Project No. 23-01-200

Re: **Modification No. 8 to the Remedial Design Report**
Closure Unit Modifications
Three Kids Mine, Henderson, Nevada

Subject: Modification No. 8 to the Remedial Design Report
Closure Unit Modifications
Three Kids Mine Site, Henderson, Nevada

LAKEMOOR CLOSURE UNIT DETAILS EXHIBIT

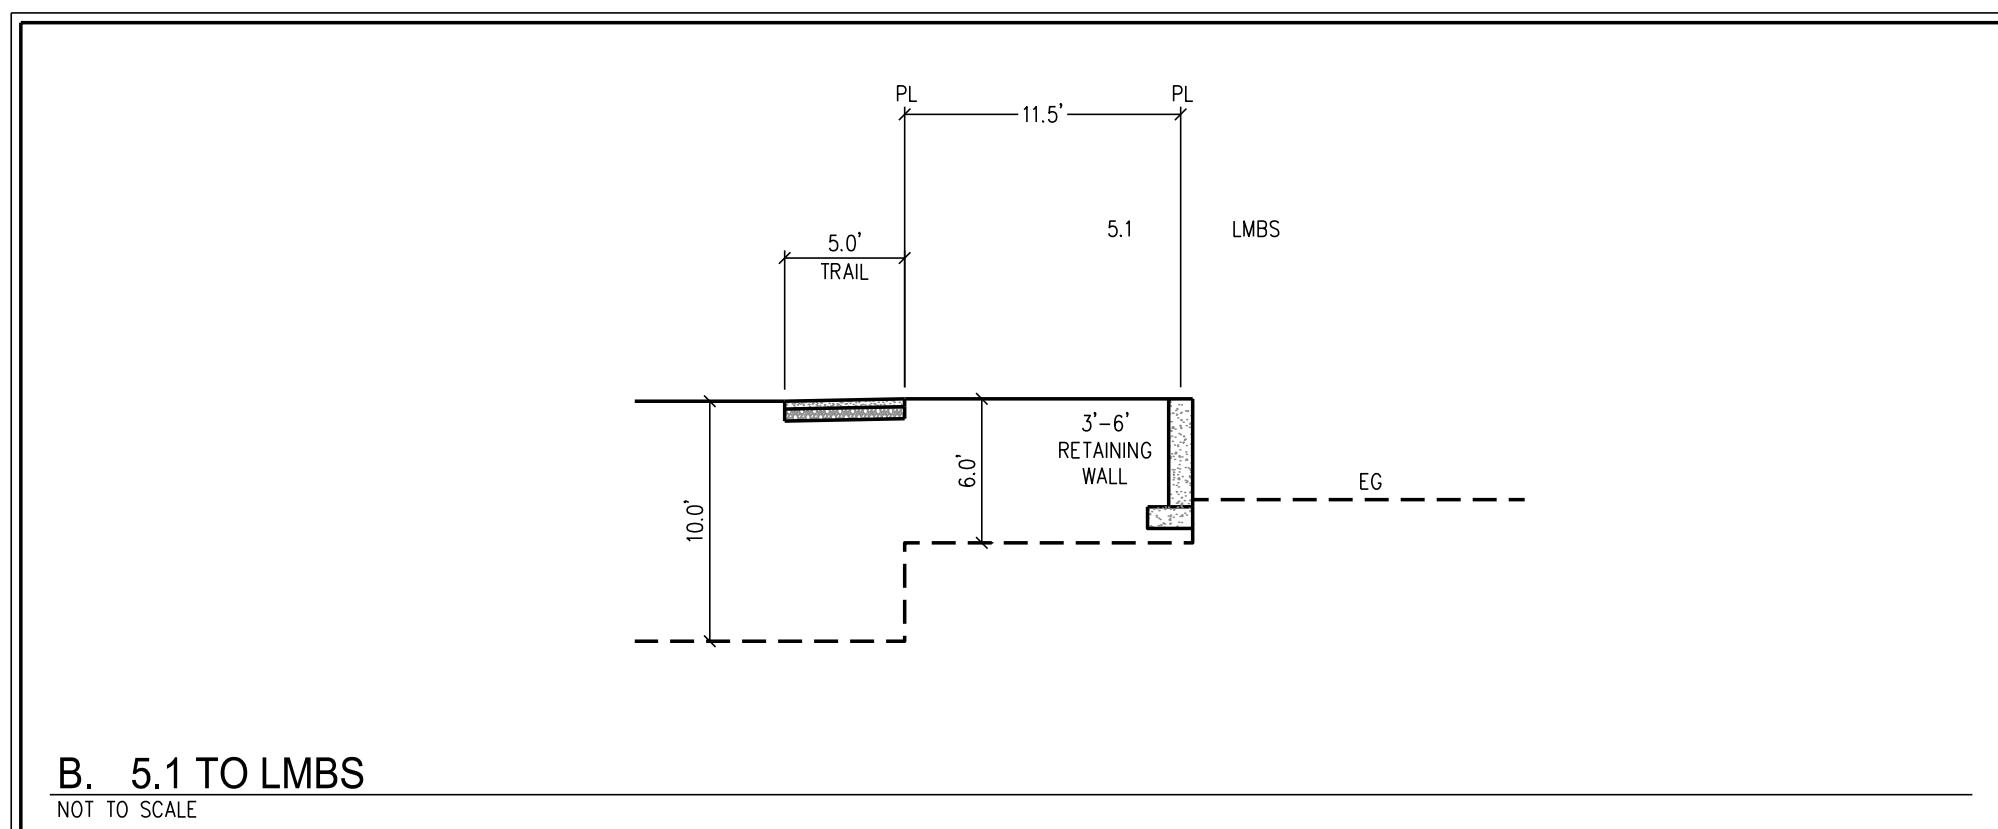
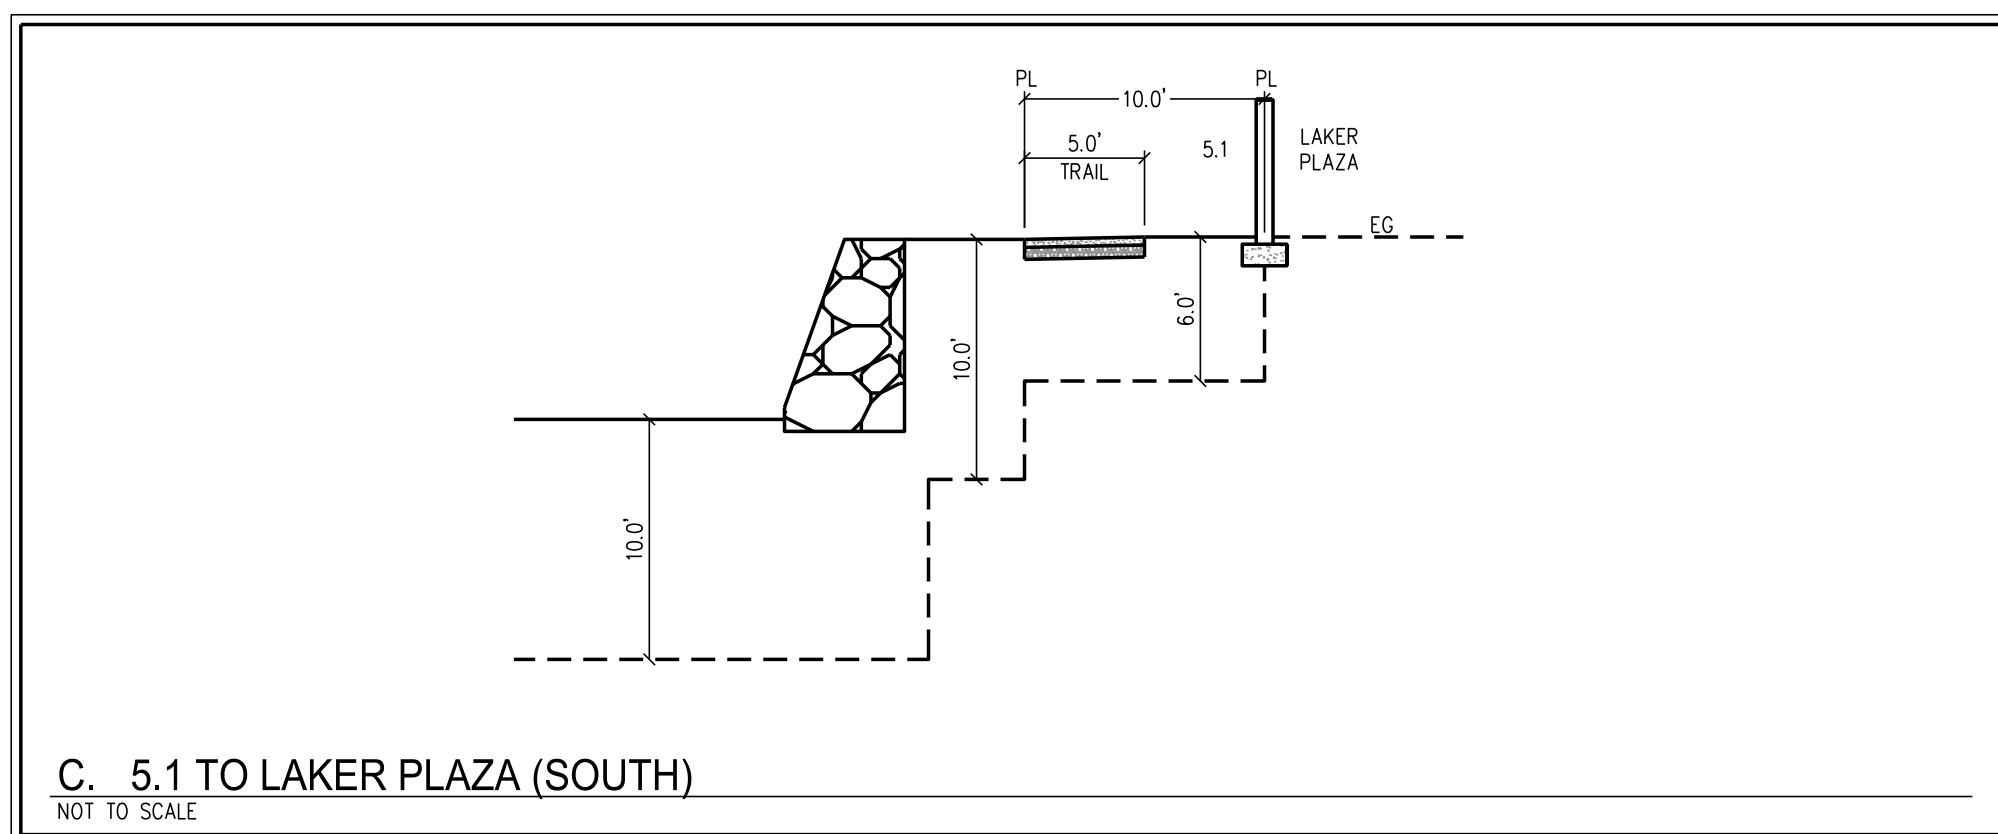
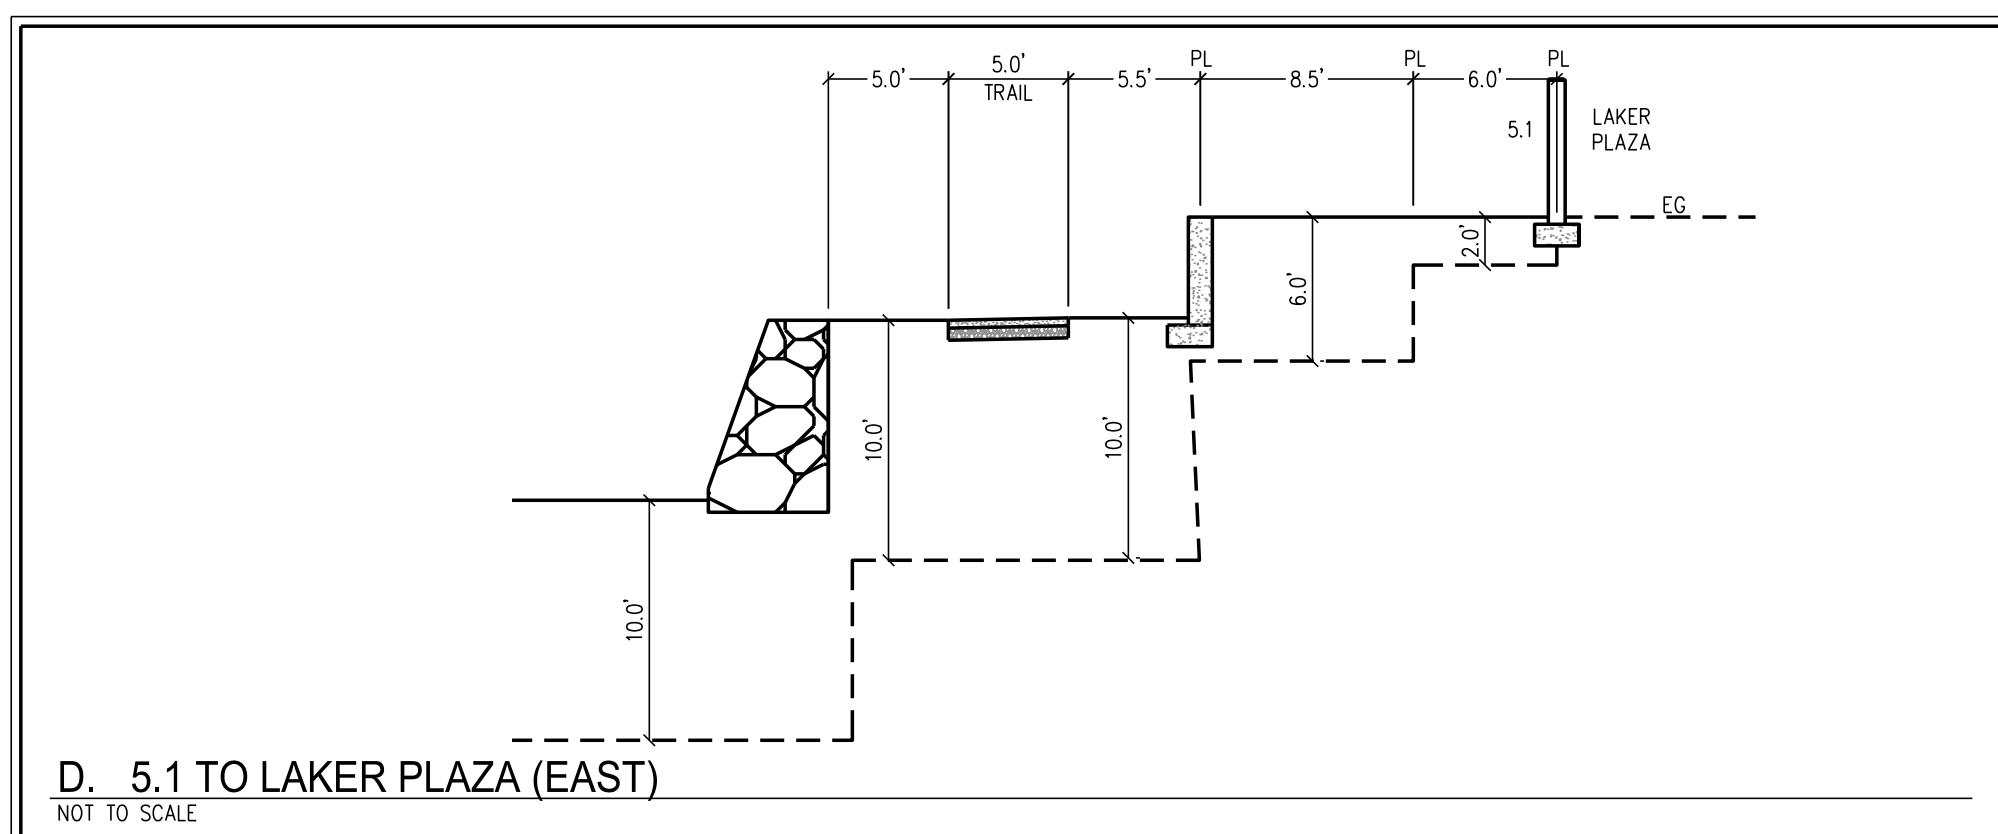
Closure Unit 11b will consist of two APNs: one APN for areas to receive a minimum of two feet of native soil cover and another APN for areas to receive a minimum of six feet of native soil cover. East of LMBS, Closure Unit 11b will consist of an 11.5-foot buffer from the property line with six feet of native soil cover (Cross Section B in Lakemoor Closure Unit Exhibit Detail). South of Laker Plaza, Closure Unit 11b will consist of a ten-foot buffer from the property line with six feet of native soil cover (Cross Section C in Lakemoor Closure Unit Exhibit Detail). East of Laker Plaza, Closure Unit 11b will consist of a six-foot buffer from the property line with two feet of native soil cover and an additional 8.5-foot buffer with six feet of native soil cover, for a total width of 14.5 feet from the property line (Cross Section D in Lakemoor Closure Unit Exhibit Detail). Accordingly, the performance standard for Closure Unit 11 as stated in Section 3.0 of the Remedial Design Report is modified from "Placement of 10-foot cover or the maximum amount of fill possible... following safe work practices..." to placement of a six-foot cover or a two-foot cover as indicated above. Areas directly adjacent to Laker Plaza on the east side are limited to a two-foot cover to avoid instability around existing structures. Other areas are receiving six feet of native soil cover so that the cover material extends two feet below utilities located at four feet below ground surface.
